Tabernacle Phase 5
CR 1-2022

Martha's Vineyard Commission
April 14, 2022

Tabernacle Phase 5

Concurrence review

2 / E101 NEW ADDITION ENLARGED PLAN - LIGHTING

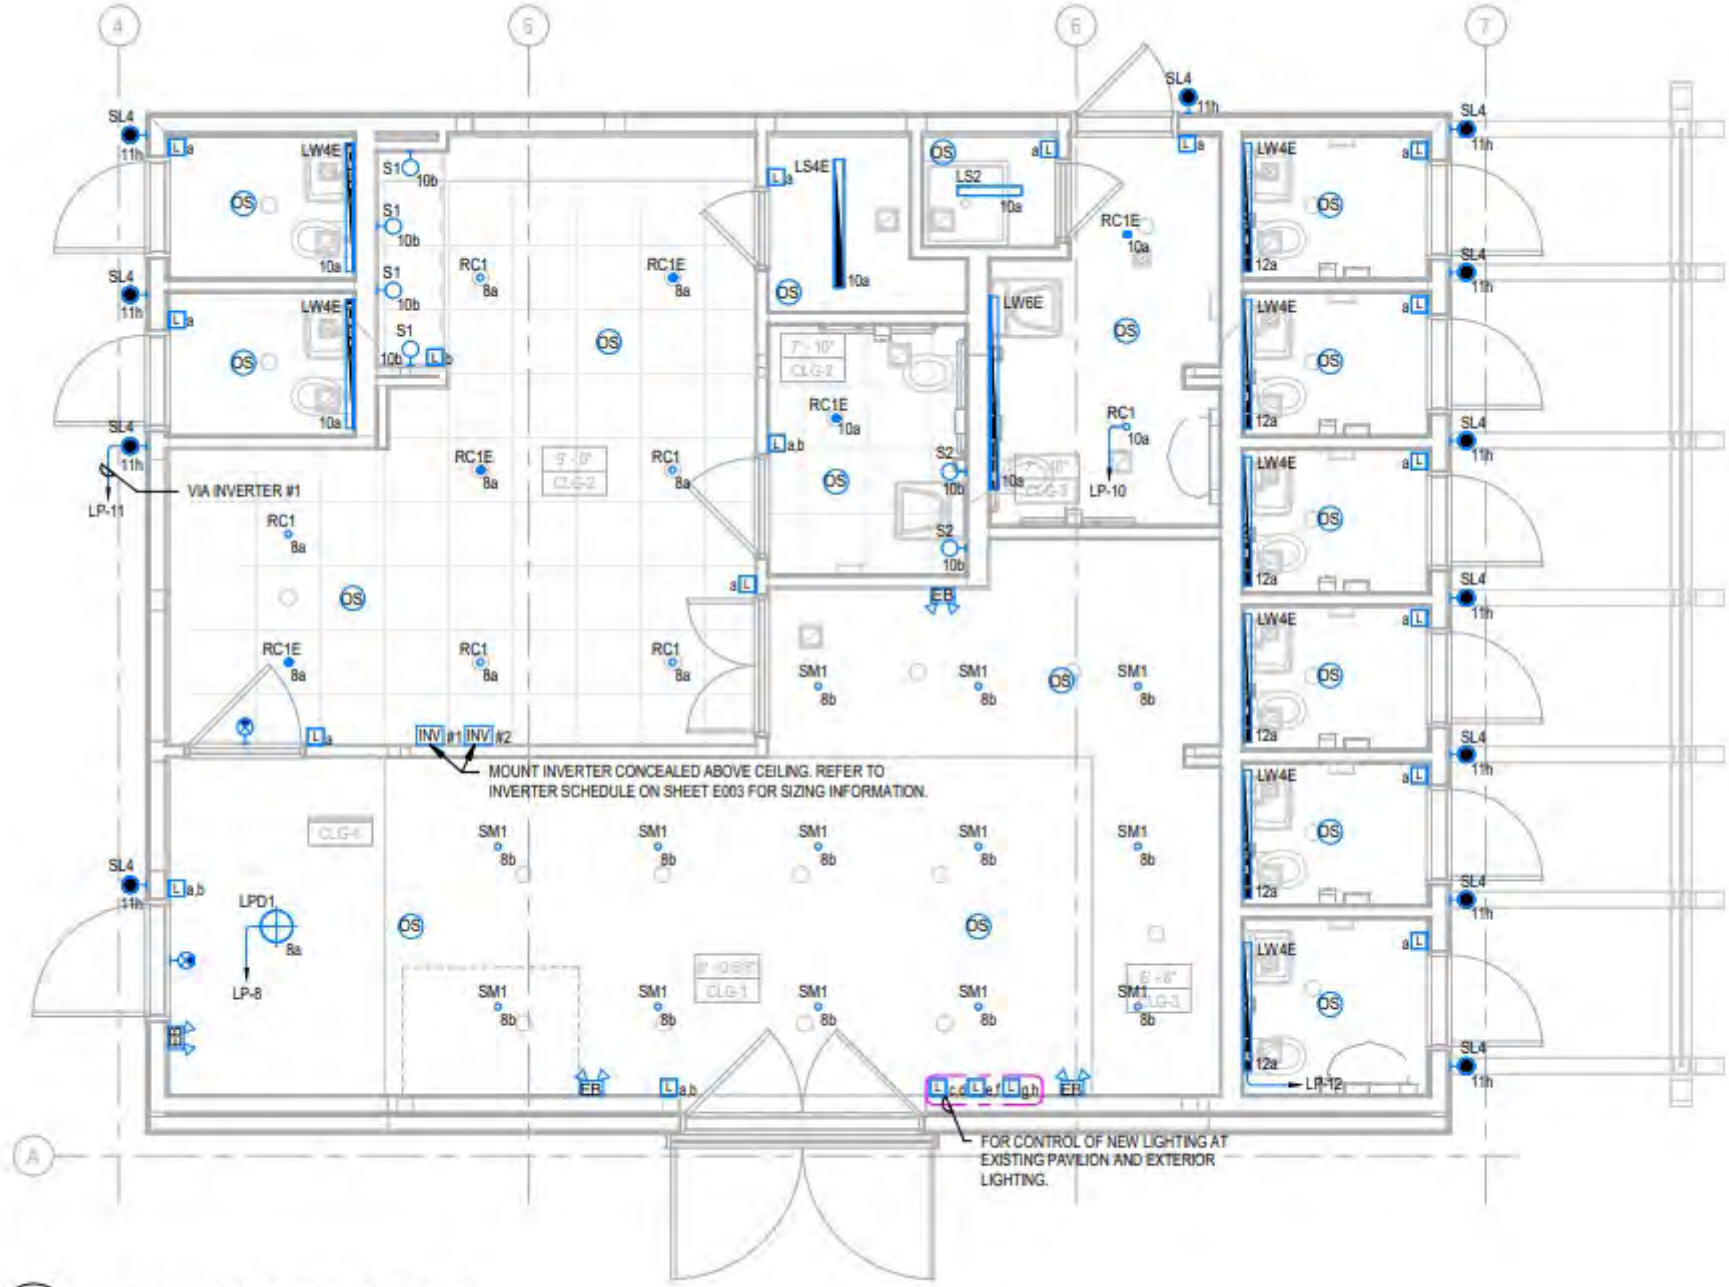
Exterior lighting would consist of downward-facing wall-mounted fixtures with automatic dimmers at 12 locations around the addition, including above each of the toilet doors. Lighting locations and fixture types for the project have been provided.
